FOUNTAIN WIND PROJECT

FINAL ENVIRONMENTAL IMPACT REPORT – VOLUME 1

April 2021

Use Permit No. UP 16-007
State Clearinghouse No. 2019012029

Comment Letter P26

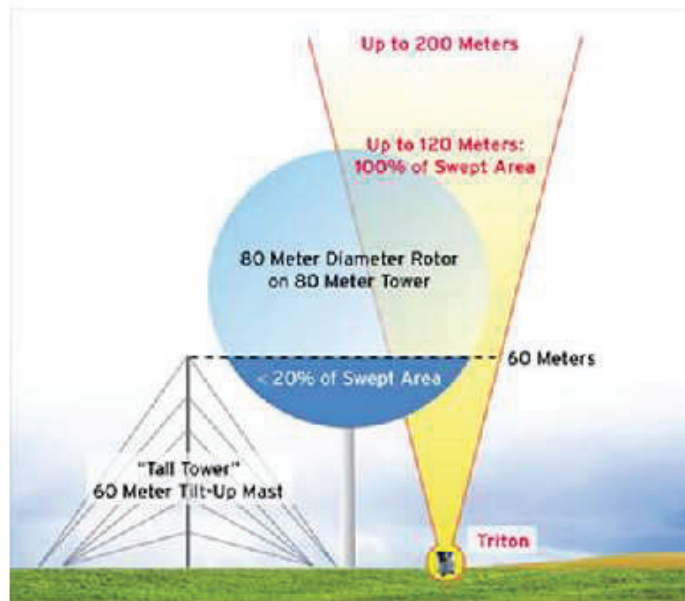
installed MET towers is insufficient to fully address and ascertain the probable power output of this Project. It is suggested that extrapolating Wind Shear characteristics based on sub-hub-height wind measurement data is inaccurate especially in a forested environment. LiDAR or SoDAR measurements and data sufficient to accurately determine the power curve and estimated power output should be included in this DEIR. How else can a clear and accurate picture of the viability of this project be determined?

↑
P26-27
cont.
↓
